Access Compliance Report

Public Rights-of-Way

Intersection ID: 8943	Main Street: FREEDOM_DR	Cross Street: WESTSTONE_DR	Location: SE
ADA ID: 283116A77009	Ramp Type: Perp	Initial Pass/Fail: Fail	Overall Compliance: No
		Severity Score: 8.75

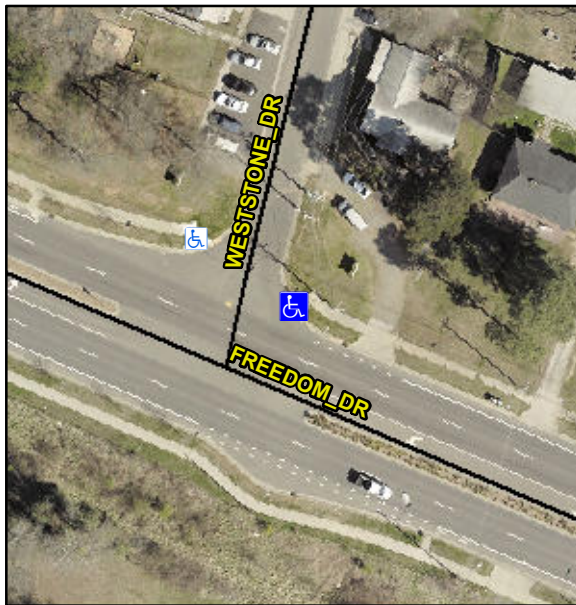
Not Found, R304.5.1

Compliance	Description	Data	Compliance	Description	Data
N/A	Ramp Length (in)	85.0	Yes	Ramp Slope (%)	7.8
No	Ramp Width (in)	47.0	Yes	Ramp XSlope (%)	1.8
N/A	Flare Type LT	N/A	N/A	Flare Type RT	N/A
N/A	Flare Slope LT (%)	N/A	N/A	Flare Slope RT (%)	N/A
N/A	Flare Traversable LT?	N/A	N/A	Flare Traversable RT?	N/A
N/A	Landing Length (in)	N/A	N/A	DWS Provided?	N/A
N/A	Landing Width (in)	N/A	N/A	DWS Contrast?	N/A
N/A	Landing Slope (%)	N/A	N/A	DWS Length (in)	N/A
N/A	Landing X Slope (%)	N/A	N/A	DWS Full Width?	N/A
N/A	Landing Curb? (Y/N)	N/A	N/A	DWS Offset (in)	N/A
N/A	Shared Landing?	N/A			
N/A	Gutter Ponding?	N/A	N/A	Gutter Slope (%)	N/A
N/A	Gutter Lip Ht (in)	N/A	N/A	Gutter X Slope (%)	N/A
N/A	Painted X Walk1?	No	N/A	Painted X Walk2?	N/A
	X Walk 1 Direction	To NW		X Walk 2 Direction	N/A
N/A	X Walk 1 Width (in)	N/A	N/A	X Walk 2 Width (in)	N/A
	X Walk 1 Slope (%)	1.9		X Walk 2 Slope (%)	N/A
	X Walk 1 X Slope (%)	1.8		X Walk 2 X Slope (%)	N/A

Remove & Replace Entire Ramp.
